MAXWELL PROJECT

Peer Review Letters

**Peer Review – Maxwell Underground Project
Subsidence Assessment
(MSEC Report 986, Revision A, July 2019)**

REPORT NO: 1905/03.1 (final)

Figure 12. Maxwell Project: Surface and seam levels along Section 1
 (source: MSEC Report No. 986, Rev. A, 2019)

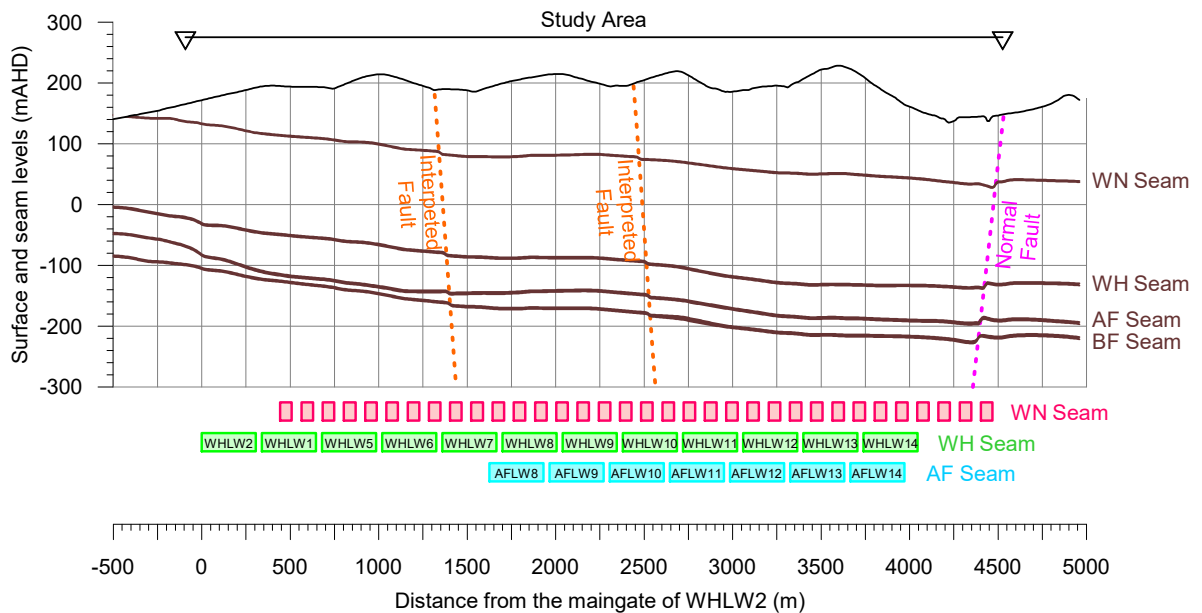
9. Figure 12 (below) is a copy of MSEC Figure 1.2, included here simply to illustrate the relative vertical configuration of the seams, relative to one another, and to the surface topography, along a typical section through the workings. This Figure also indicates three of the major faults expected to be present in the workings.

Figure 13. Surface, seam and sill levels along Section 4
 (source: MSEC Report No. 986, Rev. A, 2019)

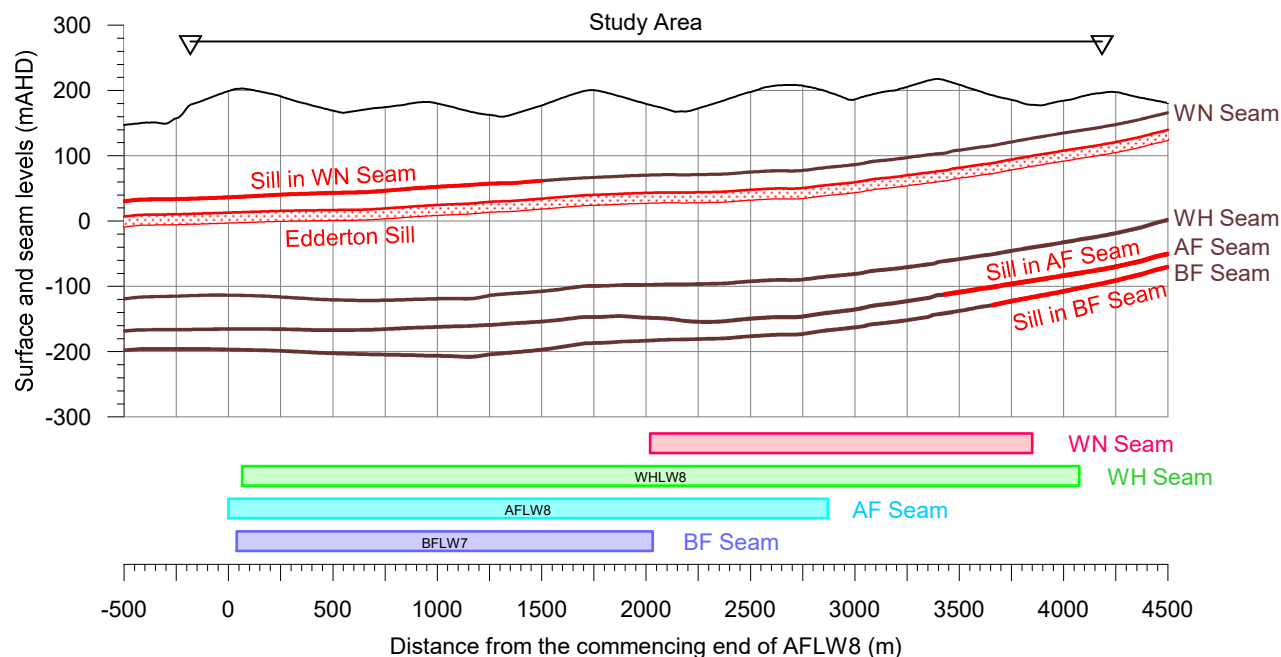
11. Page 9 and following – The presence of dolerite sill intrusions in three of the four seams in the mining area (excluding the Woodlands Hill Seam) is discussed. Mine workings have been located to avoid the sills within each seam, but their presence in the overburden could certainly impact on both underground mining conditions and subsidence effects, with potential for delayed or anomalous subsidence in some locations. The sills are stated to be up to 20m in thickness, with strengths in excess of 180MPa. An analysis by MSEC suggests that the sills will not be strong enough to span across a full longwall panel width, but over panel edges and corners, they could certainly influence the behaviour of the overburden.

Figure 13 is reproduced from MSEC Figure 1.4, showing the location of the sills along a particular section line (Section 4).

Figure 14. Maximum measured vertical subsidence versus longwall width-to-depth ratio for previous multi-seam mining cases
 (source: MSEC Report No. 986, Rev. A, 2019)

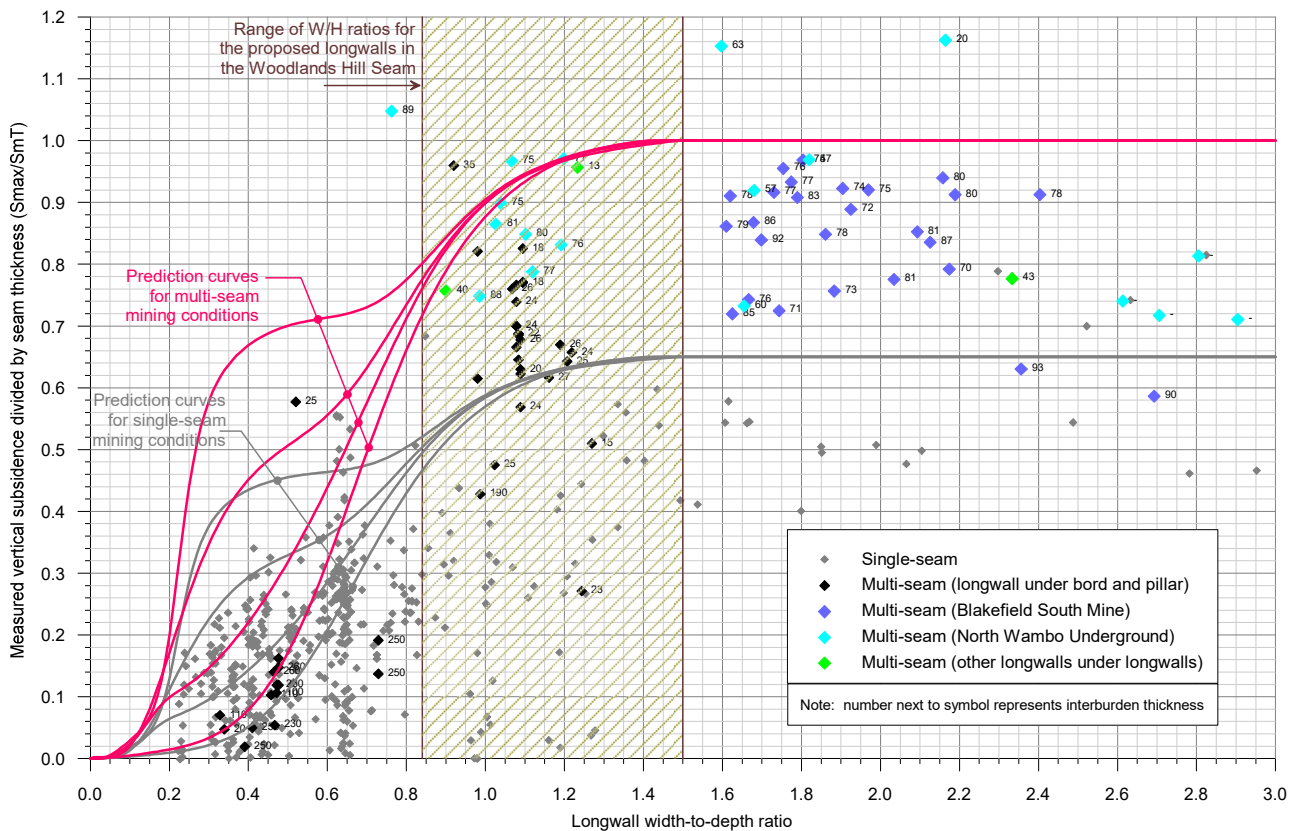
23. Figure 14 is a copy of the MSEC Figure 3.5 which illustrates the multi-seam database used for these predictions. Whilst this demonstrates a reasonable number of data points, it also clearly illustrates quite a wide range of scatter, even for the one mine, and for the one value of width/depth ratio. This further confirms that the level of confidence in the multi-seam predictions will be far less than it is with single seam predictions, at the present time. Hence a decision to use close to “worst-case” prediction factors is a prudent one, at this early stage of the project. Once actual data is gathered during operations, the understanding of multi-seam interactions will improve, as will the confidence levels for the prediction methods.
